# FAIRFAX COUNTY

## STAFF REPORT

APPLICATIONS RZ 2002-MV-020 and FDP 2002-MV-020  
and SE 2002-MV-022

SUMMIT OAKS

EXISTING VEGETATION MAP  
**SUMMIT OAKS / ENGLESDALE BAPTIST CHURCH**  
 MOUNT VERNON DISTRICT  
 FAIRFAX COUNTY, VIRGINIA  
 SCALE 1" = 100'  
 DATE: MAY 2001  
 C.E. N/A

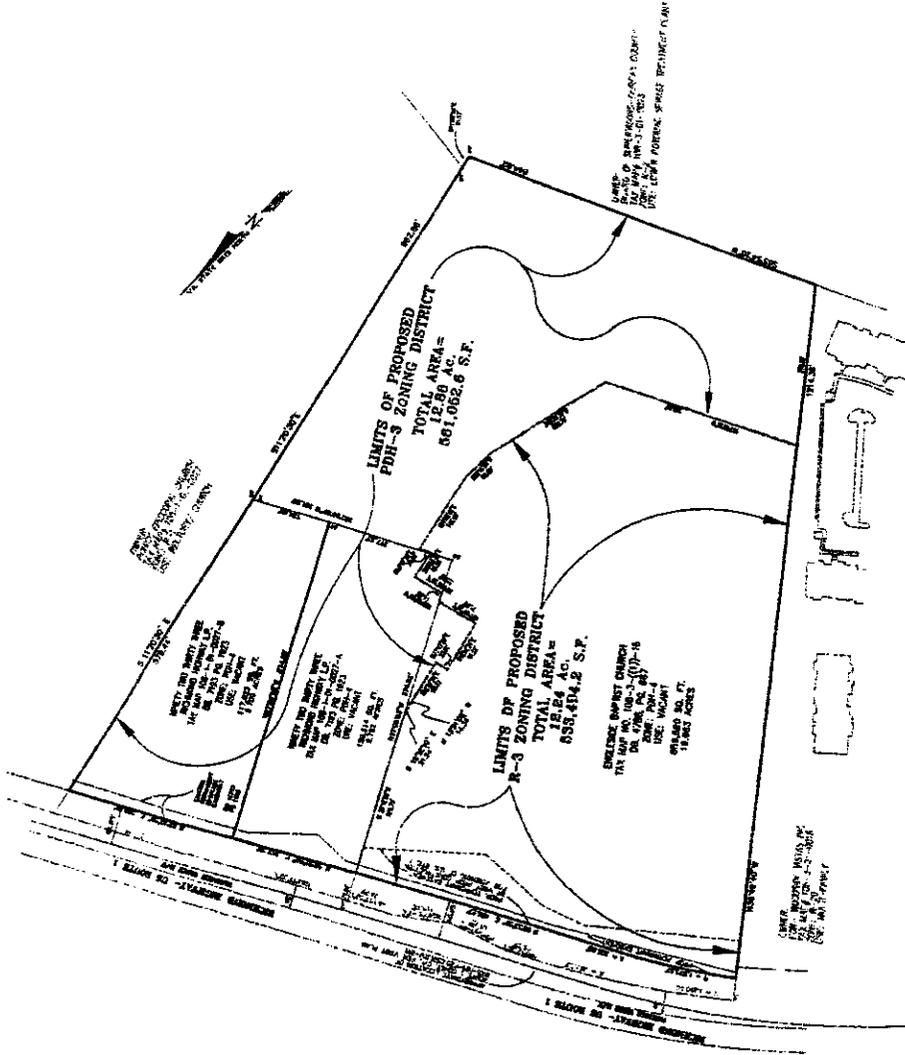
Sheet 3 is the Existing Vegetation Map which shows the following:

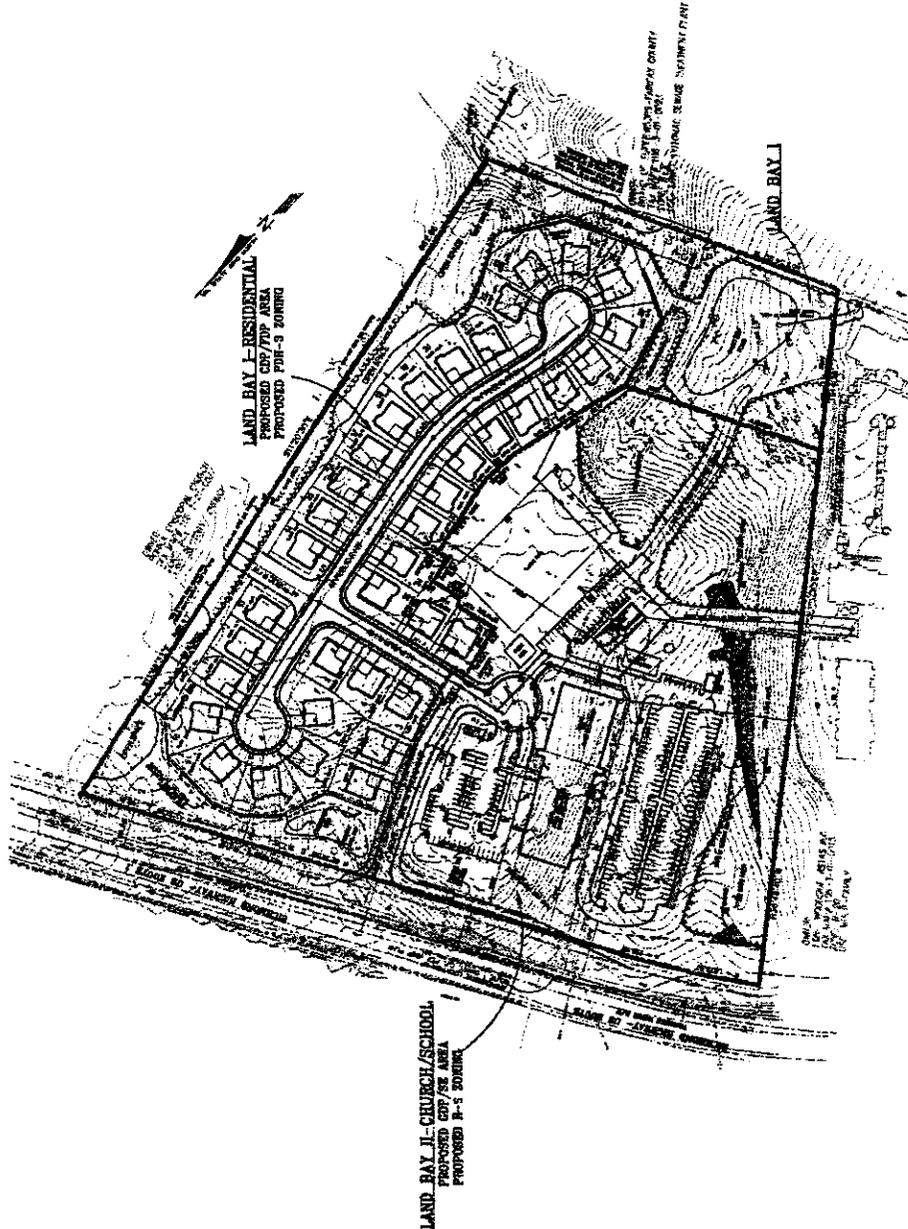
Sheet 4 is the rezoning plat showing acreages and metes and bounds for the three (3) parcels which comprise the application property. To summarize:

- The area proposed to be rezoned from the PDH-4 District to the PDH-3 District for the residential development contains 12.88 acres.
- The area proposed to be rezoned from the PDH-4 District to the R-3 District for development of the church with private school of general education is incorrectly shown to contain 12.25 acres. The area is actually 12.24 acres. The applicant has agreed to correct the discrepancy.

**PLAN OVERVIEW**

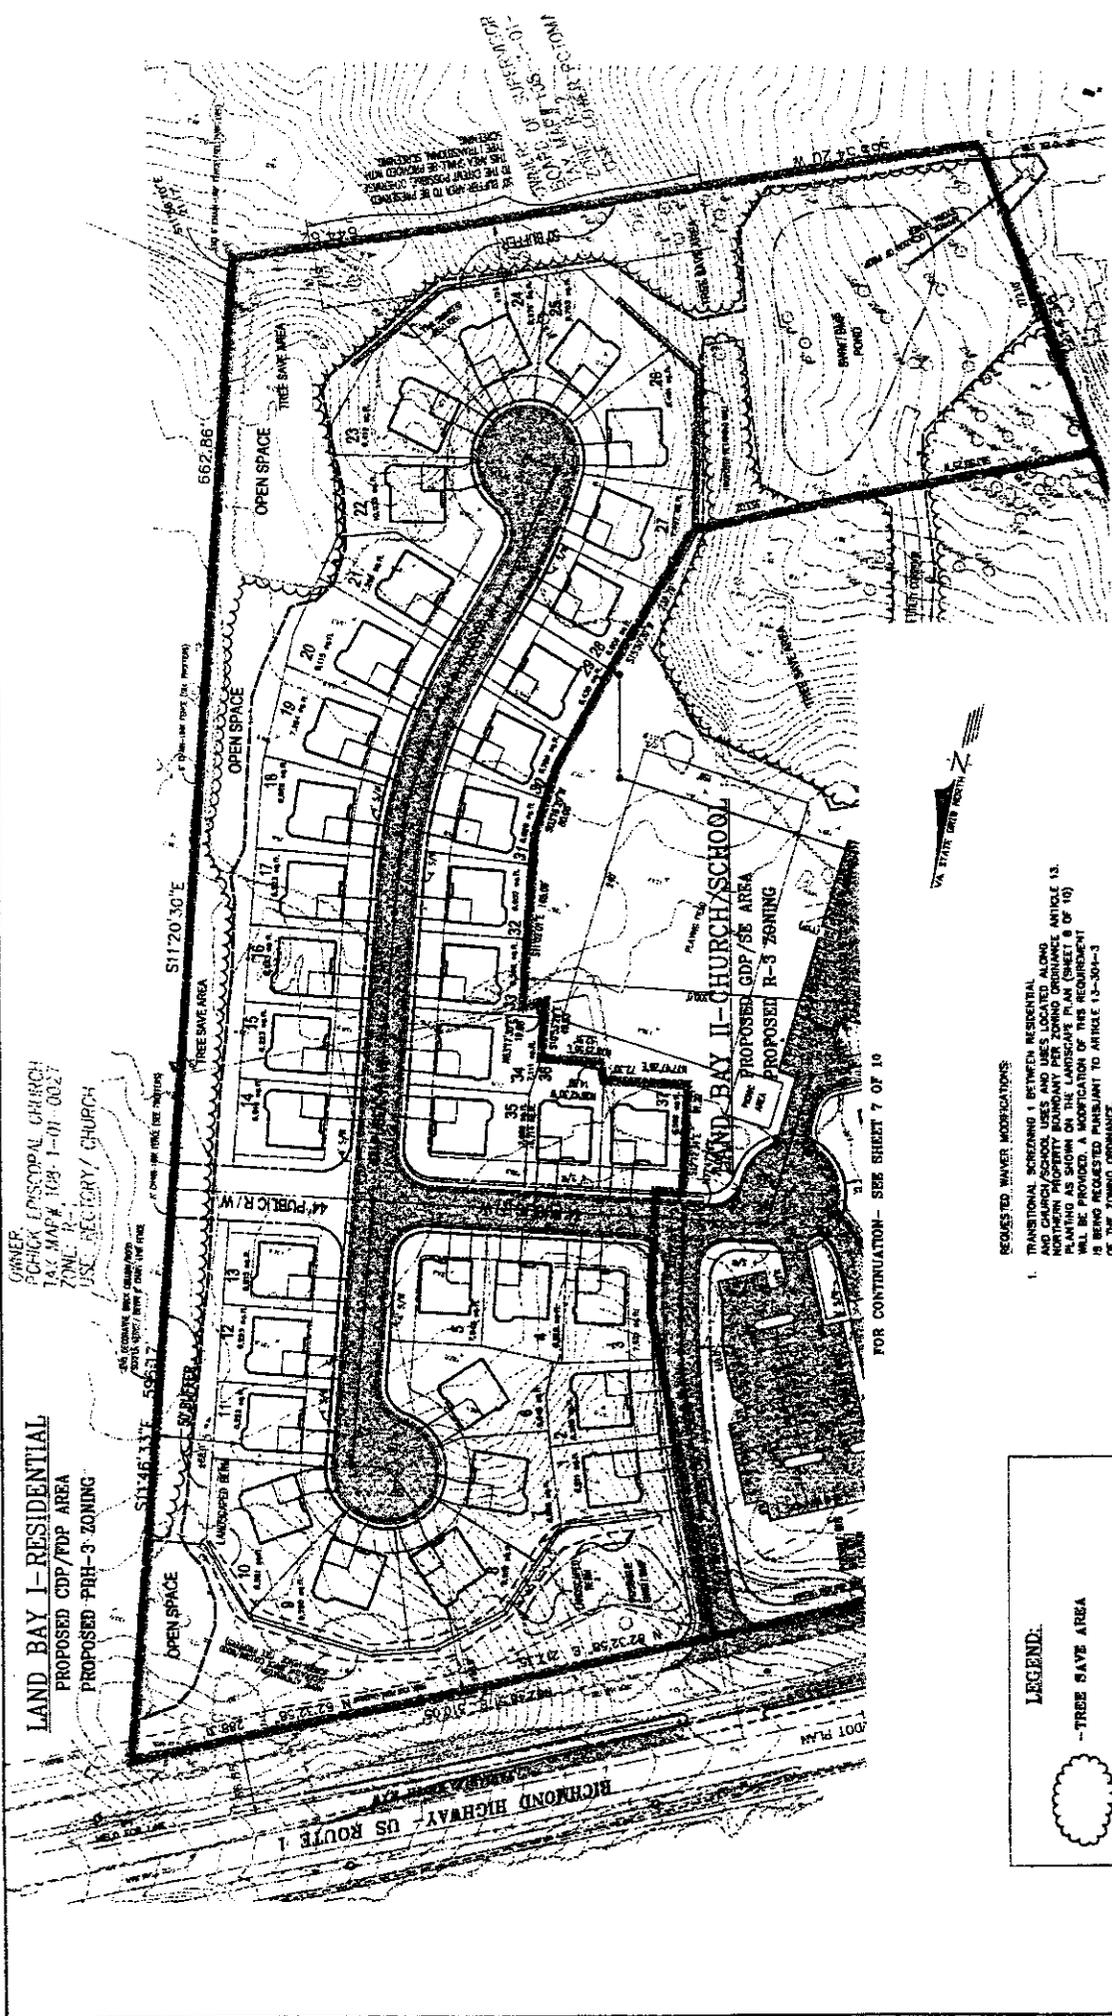
Sheet 5 is the plan overview showing the site layout for both the proposed PDH-3 development and the church/school development which is proposed in the R-3 District with approval of a Special Exception. Separate tabulations are presented for each of the proposed zoning districts as follows:

- Land Bay I, containing 12.88 acres, is proposed for the development of 37 single-family detached dwellings at a density of 2.87 dwelling units per acre
- 4.50 acres, or 34%, open space are provided
- The average lot area is 7,300 square feet. As noted earlier, the development plan shows two lots which are less than 6,000 square feet and the applicant has a note on Sheet 2 which permits minor modifications to lot sizes. Staff would like a commitment that no lot will be less than 6,000 square feet in area.
- A minimum of 74 parking spaces are required. The applicant's parking tabulations show 74 driveway spaces and 74 garage spaces; however, a note states that final parking count is subject to change with final engineering and that between 74 and 148 parking spaces will be provided. Since the

applicant's proffers state that all dwellings will be built with 2 car garages and all driveways will be a minimum of 20 feet in length, staff is not clear on why the possibility of providing only 74 parking spaces is proposed. Given the size of the lots, there will not be much room for on-street parking between driveway entrances. The applicant should clarify the parking issue.

A 1"=100 feet plan overview is presented on this sheet; 1"=50 square feet renditions of the sheets follow where site details are more clearly depicted. To summarize, this sheet shows the proposed residential and church/school uses with common access via a 50 foot public right-of-way from Route 1 which terminates in a T-intersection on site. This main entrance road is primarily located on the portion of the site proposed to be developed with the church/school uses. Access to the residential development, which is shown as a 44 foot wide public right-of-way, branches off toward the east from the T-intersection. A 44 foot public right-of-way extends westward from the intersection for approximately 60 feet into the church/school development which is accessed via a private street network.

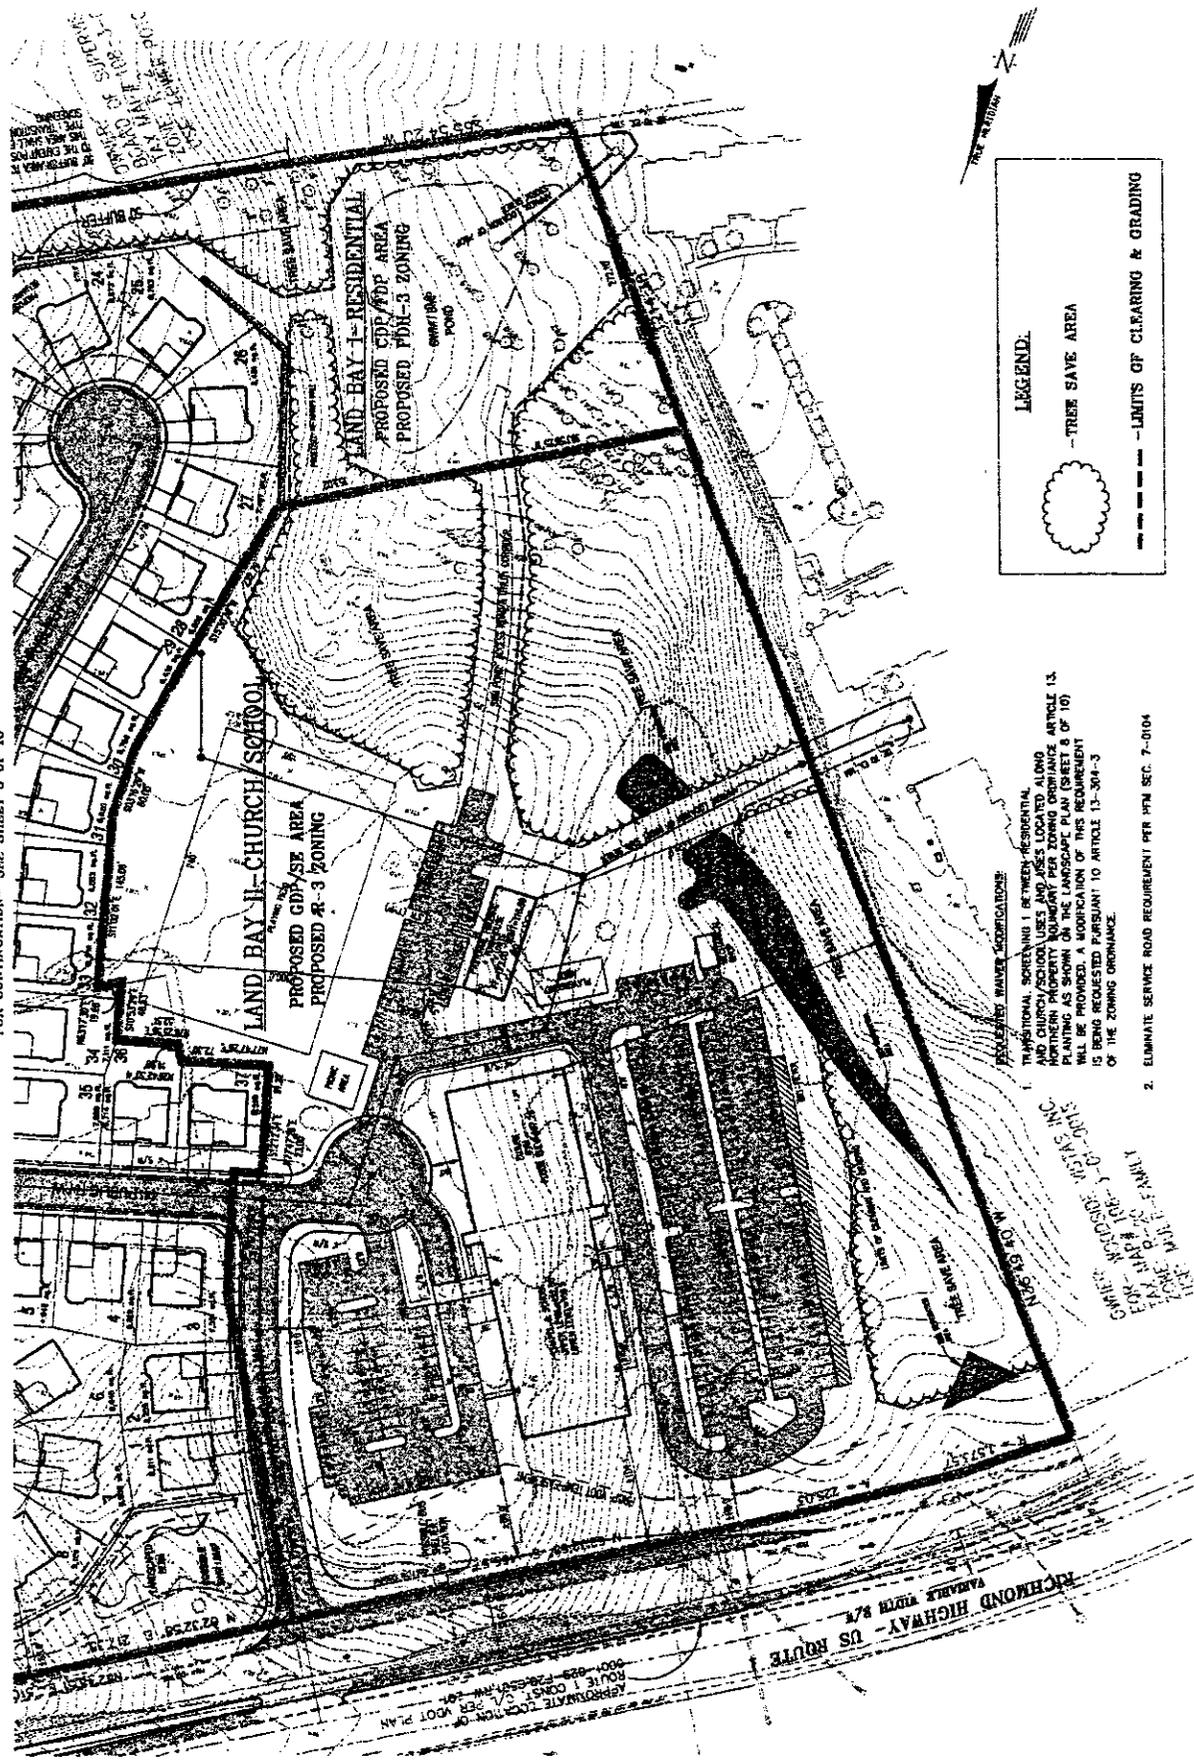
Sheet 6 is the CDPA/FDPA layout of the proposed PDH-3 development at the 1"= 50 feet scale and is summarized as follows:

- 37 lots are proposed which range in size from 5,769 square feet to 10,033 square feet. Average lot size was shown on an earlier sheet to be 7,300 square feet. The proposed lots near the front of the site, Lots 3-4 and 6-10 are located in an area of steep slopes some of which exceed 15%, according to the Environmental Assessment Map contained in Appendix 9.

- A 44 foot wide public right-of-way extends eastward to the common boundary with Pohick Church to provide interparcel access. The applicant's proffers states that this right-of-way shall be dedicated in fee simple to the Board of Supervisors and that "The existence and configuration of the dedicated right-of-way and the permitted nature of a future public street connection shall be disclosed in writing to all purchasers. To provide additional notice, the area of the dedicated right-of-way shall be clearly marked with a sign identifying the areas as 'future permitted public street connection' or similar. The public street shall be terminated in this area using a 28 foot wide curb return." Department of Transportation staff has indicated that they will not support this interparcel access unless the applicant constructs a stub street to the property line because of concern that citizens may object to the paved interparcel connection when it is needed. In addition, maintenance responsibilities need to be clarified because VDOT will not maintain this paved section until it is extended.

22 feet to 8 feet in width adjacent to Lots 10-19 to the west. No landscaping is depicted or proffered for these cleared areas. The Comprehensive Plan calls for "substantial buffering" adjacent to the Pohick Church. With the proposed clearing and grading which will likely damage trees in the adjacent tree save area, the actual width of a vegetated buffer is significantly less than 50 feet. While staff has proposed a development condition which requires supplemental plantings in the area located within 50 feet of the eastern property line, as deemed necessary by the Urban Forester, staff is concerned that the proposal, as submitted, does not provide the substantial buffering called for in the Comprehensive Plan.

- An open space area consisting of tree save areas and a 50 foot buffer is located along the southern property boundary, adjacent to the Lower Potomac Pollution Control Plant. Adjacent to Lots 24 and 25, a proposed retaining wall, of undisclosed height, is depicted in an area to be cleared and graded for its construction within the buffer. With the retaining wall located within the area labeled as a 50 foot buffer, this area should be re-labeled to reflect the actual width of the buffer which is approximately 40 feet. Staff has proposed a development condition which requires supplemental plantings in this area also.

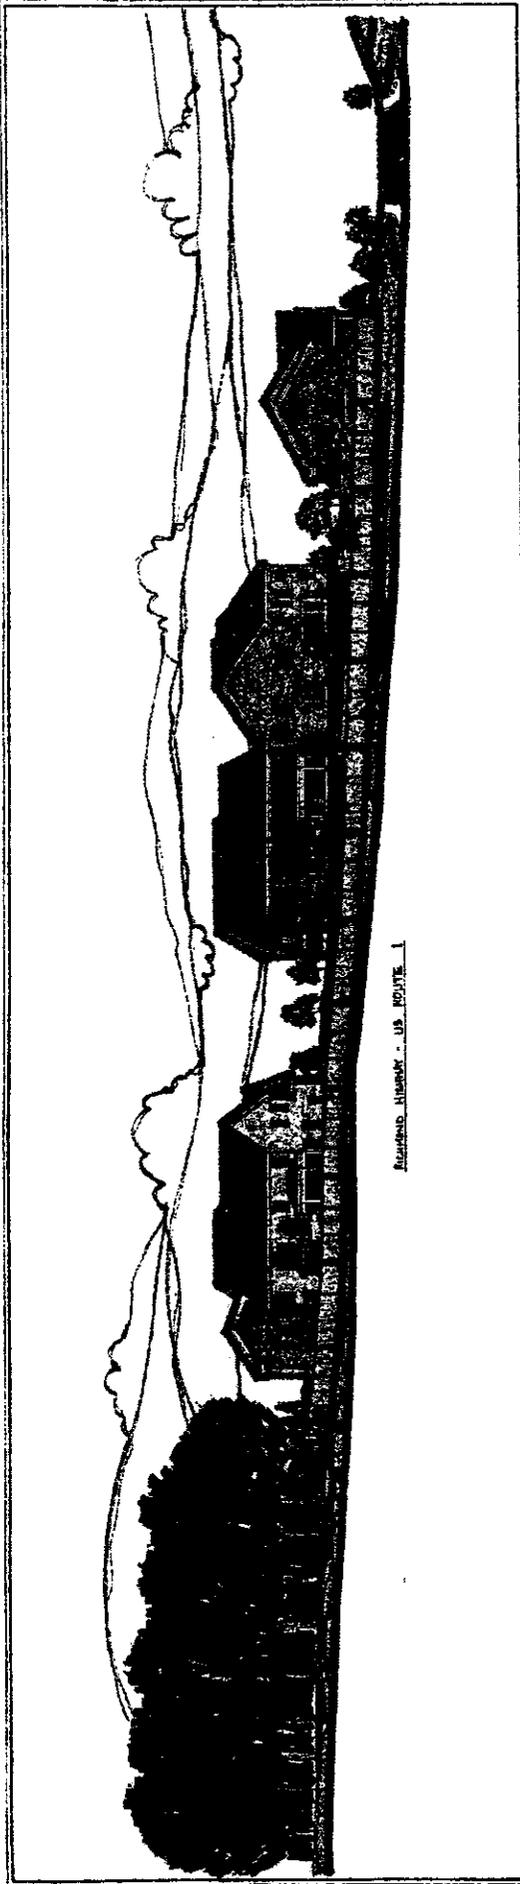
Sheet 7 is the GDP/Special Exception Plat for the Engleside Baptist Church which shows the following:

- The proposed playing field scales to be approximately 150 feet by 240 feet. The applicant has not specified its size or its hours of use and who will be able to use it. Staff requested that it be relocated further from the adjacent residential development and from an area of slopes located in its southeastern corner; however, the applicant declined to make the change.

- A small picnic area is depicted between the parking lot and playing field. A playground area is shown west of the pastoral housing, adjacent to the parking lot. No information is provided regarding how the picnic area will be developed or used and no dimensions have been provided for the play area. The pastoral housing is intended to provide permanent residences for church employees.

- A 35 foot wide cleared utility corridor extends from the southern end of the central parking lot to provide access to the proposed SWM/BMP facility

located in the southwest corner of the PDH-3 section. The utility corridor bisects a large tree save area which contains steep slopes. The applicant has indicated that there is no alternative to this location for the required maintenance access to the SWM facility which will provide SWM/BMPs for the majority (approximately 70%) of the application property. The applicant's draft proffer states that "The location and configuration of the stormwater management facility shown on the Plan is conceptual and subject to change based on final engineering; however, in no event shall any permitted reconfiguration of the stormwater management ponds diminish the tree preservation areas identified on the plan." Staff has requested the applicant proffer to strict conformance with the limits of clearing and grading to protect tree save areas. The applicant also proposes a proffer which allows utility lines, trails, etc. to be located in landscaped areas or outside the limits of clearing and grading in tree save areas, as determined necessary by the Director. In such instances, the proffer states that "...the limits of clearing and grading shall be adjusted elsewhere on the site to ensure that any trees or vegetation lost as a result of such utility locations are preserved in equal or greater amounts and quality in other areas of the property...." This proffer assumes the presence of alternative areas of quality trees, not proposed to be saved, that can be substituted for the protected areas within the limits of clearing and grading which is not the case. The tree save areas depicted on this plan were developed in coordination with staff, in particular the Urban Forester, and should be respected as they are shown. An approximately 35 feet wide cleared area for a proposed sanitary sewer connection to Woodside Village is shown extending west from the central parking lot. This utility clearing also bisects the tree save area along the west which contains steep slopes. Again, it is critical for strict adherence to the limits of clearing and grading to occur to protect these wooded areas.

- Three (3) tree reforestation areas are defined primarily within the tree save areas in the western portion of the site which, according to the February 20, 2002, Memo from the Urban Forestry Division, has approximately fifty percent (50%) of the original tree cover left intact. Some trees in this area have been damaged from the logging and there are downed trees and logs throughout this area. The applicant has submitted a proffer to address reforestation which requires submission of a reforestation plan with the first and all subsequent site plans for the R-3 zoned area, subject to the review and approval of the Urban Forestry Division. As part of the plan, all portions of the site in the R-3 zoned area shall be evaluated for the removal and/or treatment of non-native, invasive vegetation. If deemed appropriate, such vegetation will be removed.

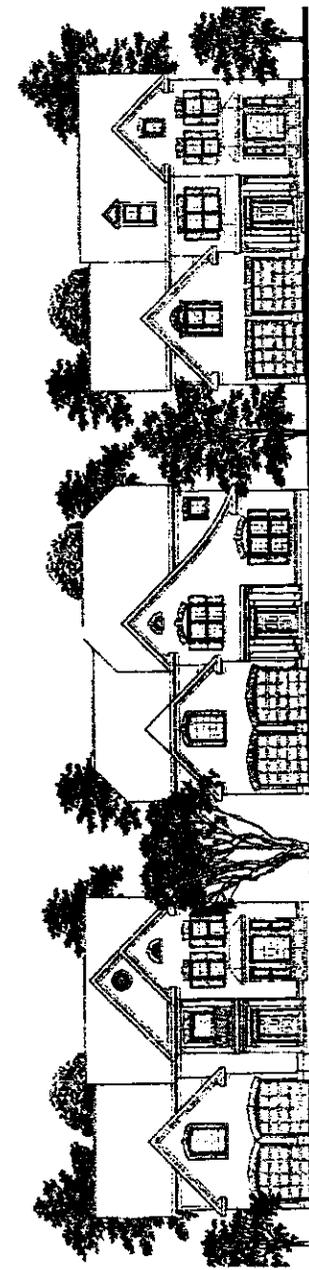
Sheet 10 are front elevations of the residential dwellings, also labeled "For illustrative purposes only". A variety of front elevations are depicted which show various options in materials and layout. Building materials are not labeled and are unclear. Staff has requested the applicant to provide clarification on building materials. All units are two-story traditional designs with two-car front load garages. The applicant's proffers require the architecture of the residences to be in substantial conformance with the general character described on the drawings and note that final approval of the residential architecture is subject to review and approval of the Architectural Review Board (ARB). The applicant's proffers also state that the rear architecture of those units abutting Richmond Highway shall be in substantial conformance with the renderings contained in the plans; however, only front elevations are depicted. The proffer states that the rear of the units abutting Richmond Highway shall incorporate windows, window treatments, and decorative elements (such as shutters and/or standing seam metal accents above bay type windows) of a type and material that is consistent and compatible with that used on the front façade. Staff has requested the applicant to revise this proffer to provide continuity in building materials between the front and back of units.

6. The architecture of the approved units shall be in substantial conformance with the general character described on the conceptual renderings shown on Sheet 10 of the Plan. It shall be further understood that final approval of the residential architecture is further subject to review and approval by the Architectural Review Board (ARB). This proffer shall not preclude implementation of the requirements imposed by the ARB. The required ARB approval shall occur prior to the issuance of building permits.
